**HERITAGE PRESERVATION COMMISSION REPORT**  
Certificate of Appropriateness for Major Work- 10<sup>th</sup> & Cass Historic District.  
Section 115-319(d)(2)  
CARRIAGE HOUSE – Ordinance 115-390(1)(d)(2)

**TO:** Heritage Preservation Commission  
**FROM:** Planning Staff  
**MEETING DATE:** April 22, 2021

**PROPOSAL:** The applicant is proposing to demolish the existing accessory structure and construct a new one that will be 34' in height. The primary residence is located at 1024 Cass Street and the proposed accessory structure will be accessed from Cass Street.

**Front Elevation**

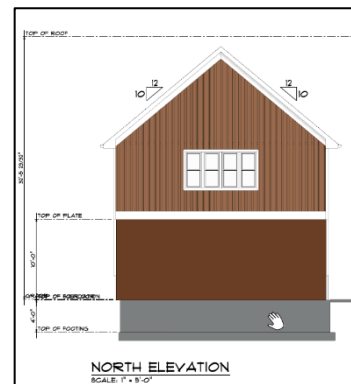
The front elevation (facing Cass St) includes a decorative overhead garage door on the first floor and a bump out with four double-hung windows under a shed roof on the second floor. The façade also includes an open gable with gable returns. A The first 3ft will consist of manufactured stone. The remaining portion of the first floor will be clad in smartboard siding with a clapboard appearance. There is a white, horizontal band breaking up the upper and lower portions of the structure. The upper story will be clad in board-and-batten smart siding.

A metal overhead door is proposed. While decorative it would be considered without ornamentation. No detail was provided on the service door however, it would be mostly screened from the street.

The proposed windows are slightly smaller but match (double-hung) the type used on the primary structure.

**NORTH ELEVATION**

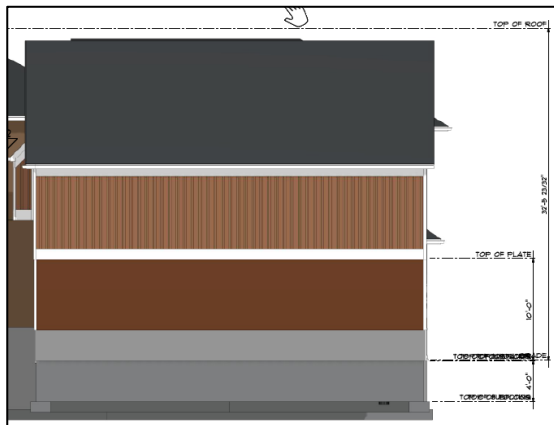
The north elevation (rear) The first floor will be clad in smartboard siding with a clapboard appearance. There is a white, horizontal band breaking up the upper and lower portions of the structure. The upper story will be clad in board-and-batten smart siding. The upper floor also includes four, side-by-side, double-hung windows.
